Change in Appearance of Input/Output Signal Connectors of General-Purpose AC Servo Amplifiers

Date of issue	April 2020	Title	Change in Appearance of Input/Output Signal Connectors of General-Purpose AC Servo Amplifiers	Mitsubishi Electric Corp., Nagoya Works 1-14, Yada-minami 5-chome, Higashi-ku, Nagoya 461-8670 Tel.: +81 (52) 721-2111 Main line
----------------------	------------	--------------	---	--

MR-J4-10GF	Before change	After change	MR-JN-10A	Before change	After change

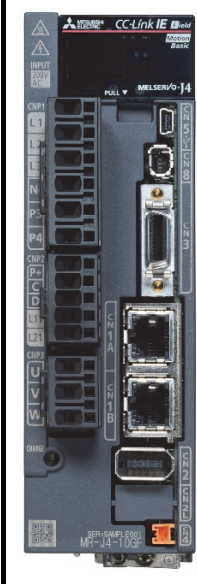
The input/output signal connectors will have tapped holes instead of lock nuts. The existing connector sets and cables will fit into the changed connectors properly.
